## &lt;Addendum #2&gt;

**Date: August 29, 2012**

**PROJECT #: EL-0006-C01**

**DESCRIPTION: Elizabeth Academic High School**

**DETAIL 'B'**

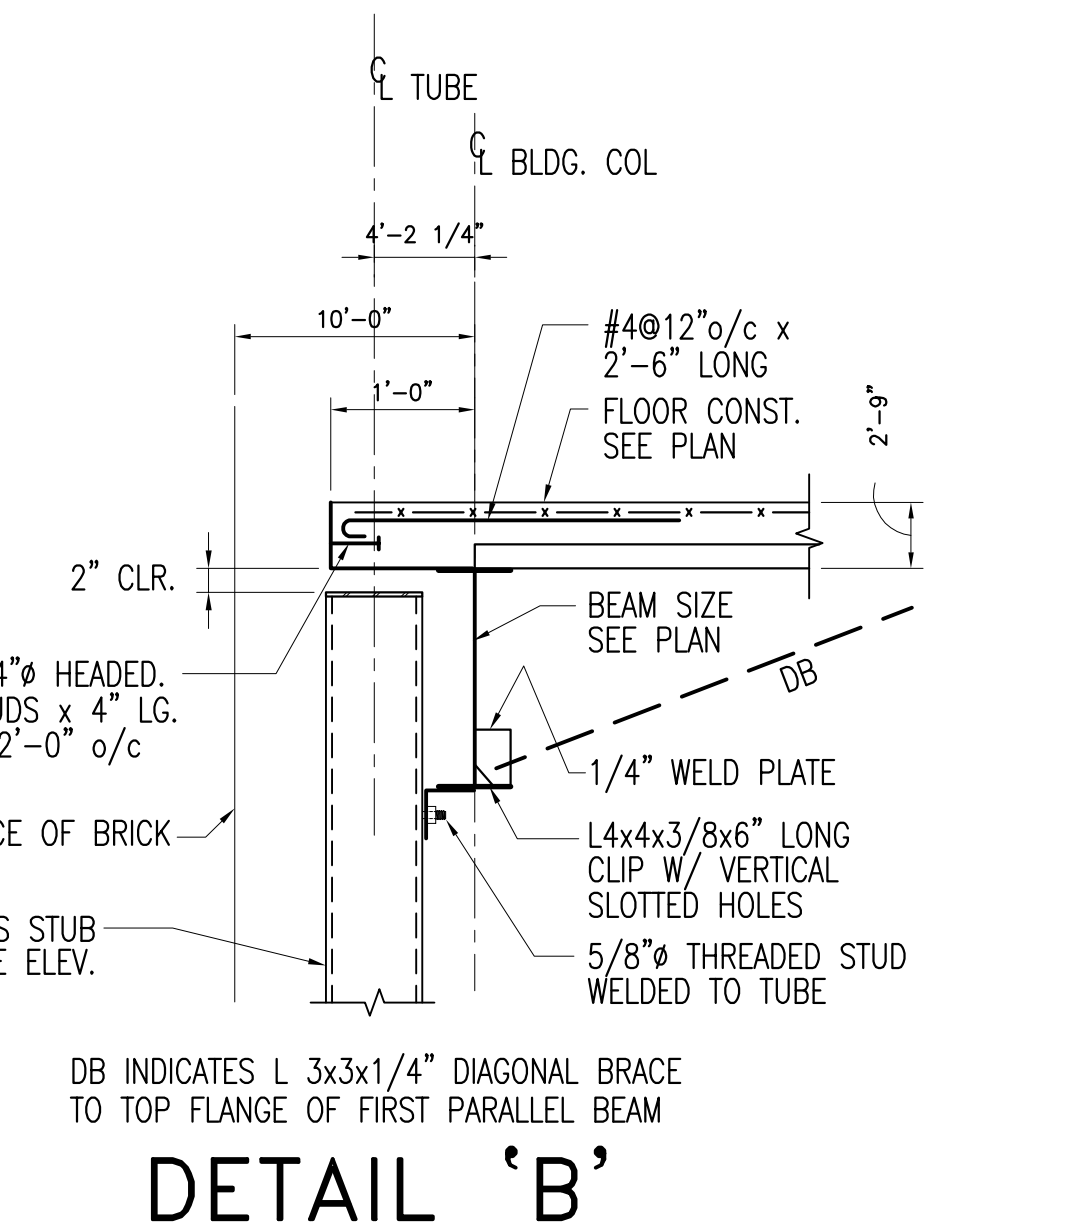
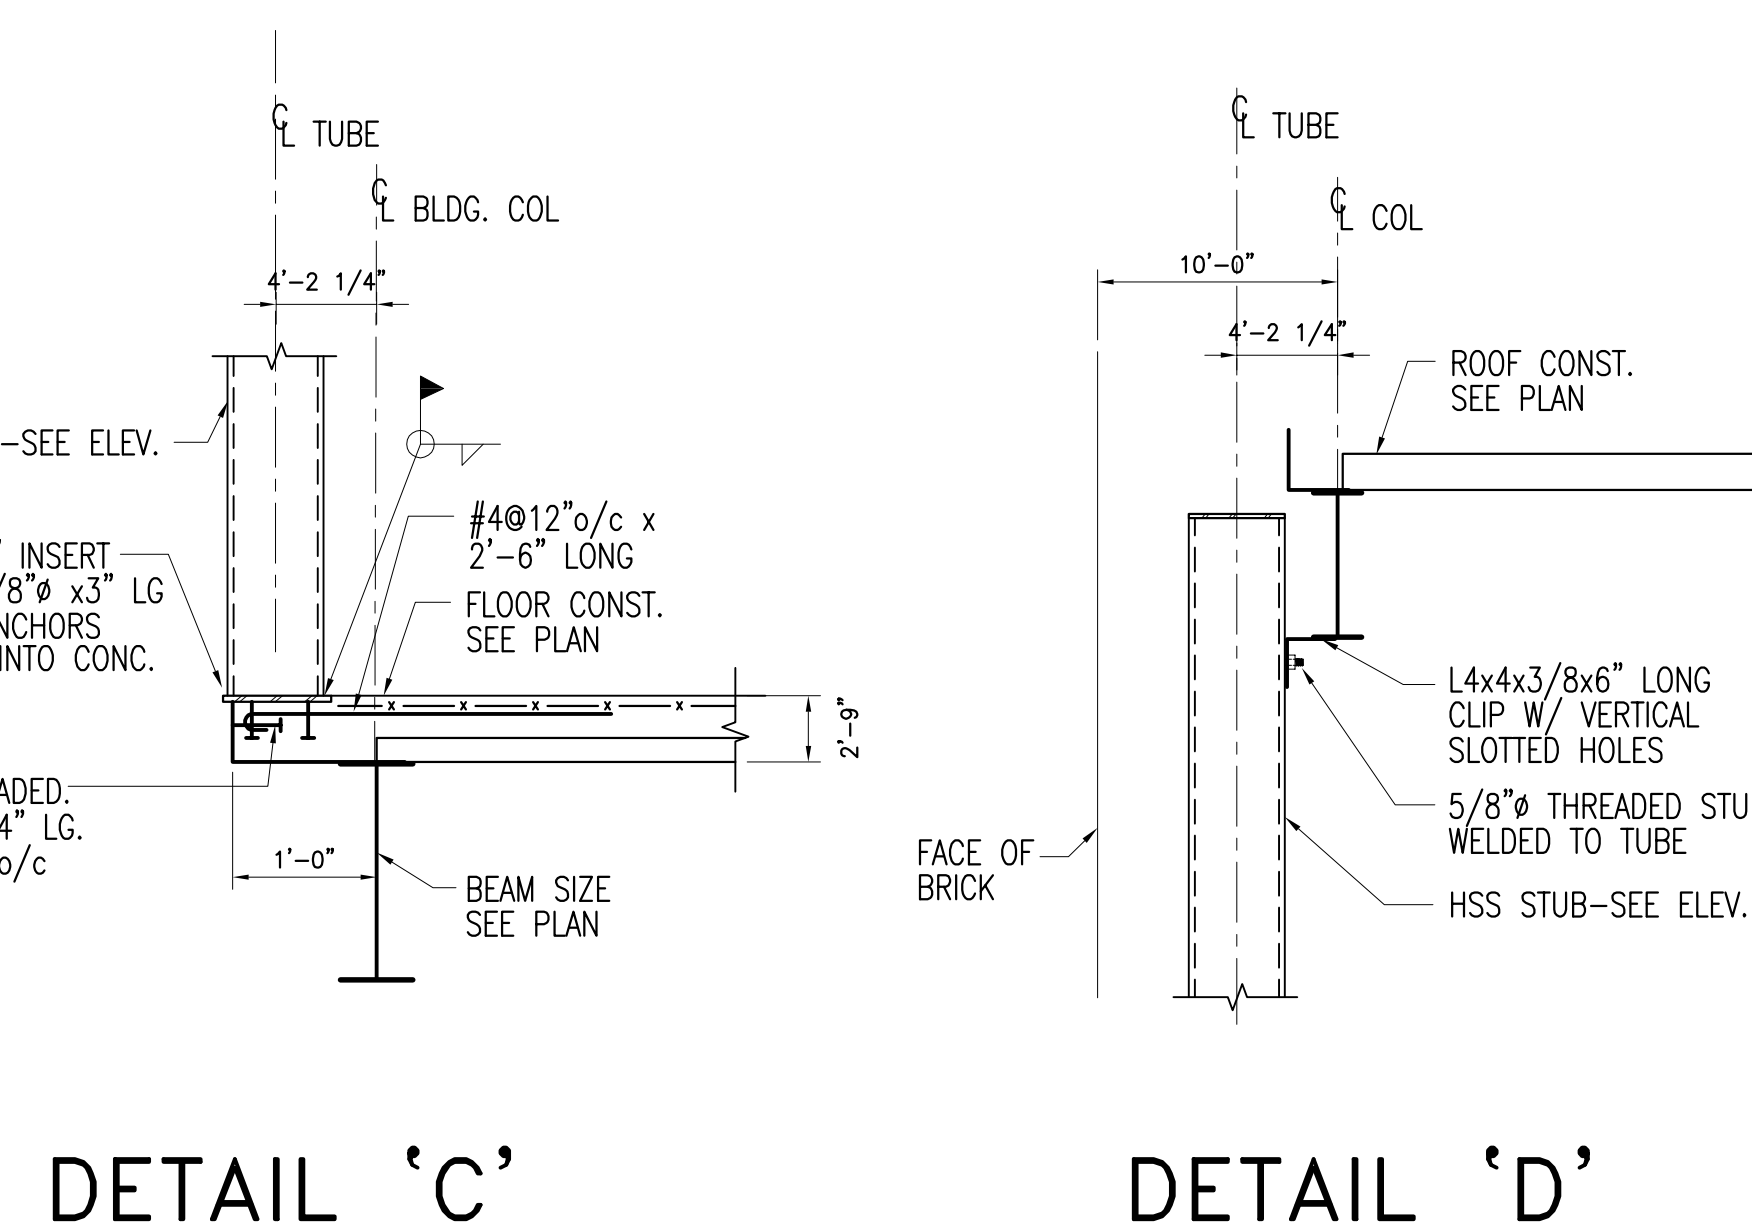
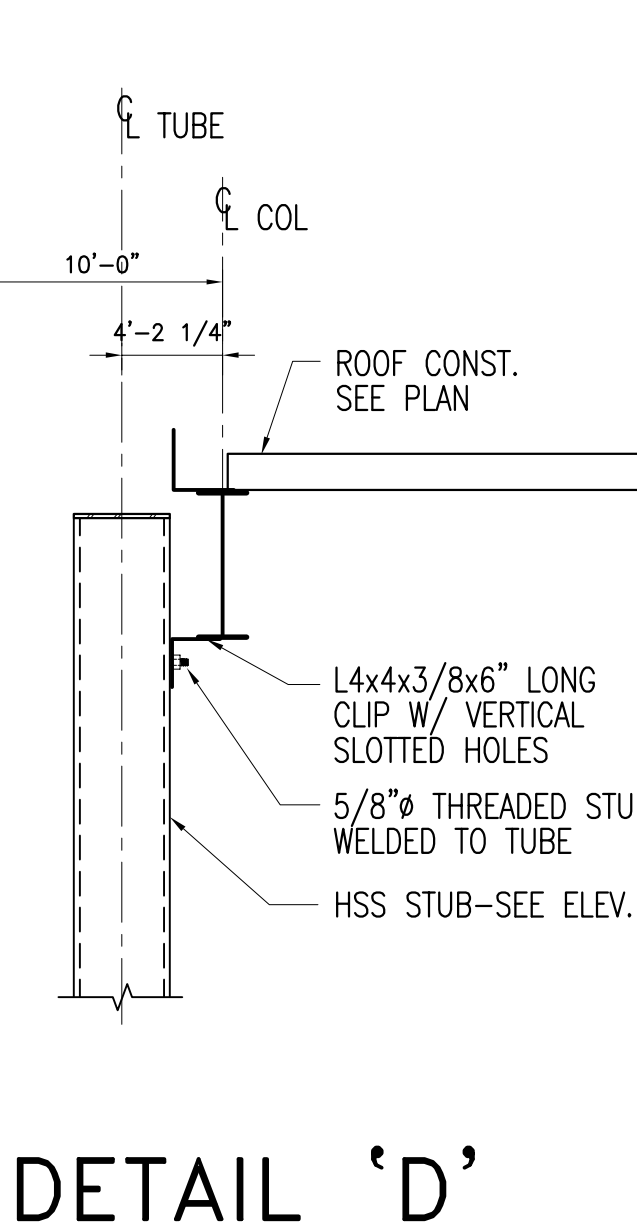
**A.20 Question:** Drawing S-106B Details 1 -4 and A – D dimensions are very small and unreadable. Please reissue in larger font.

### **B.4**   **Drawing S-106B**

Attachment #5 – Revised Drawing S-106B with more legible dimensions on details, in response to Question A.20.

**Answer:** See revised Drawing S-106B (Attachment #5).
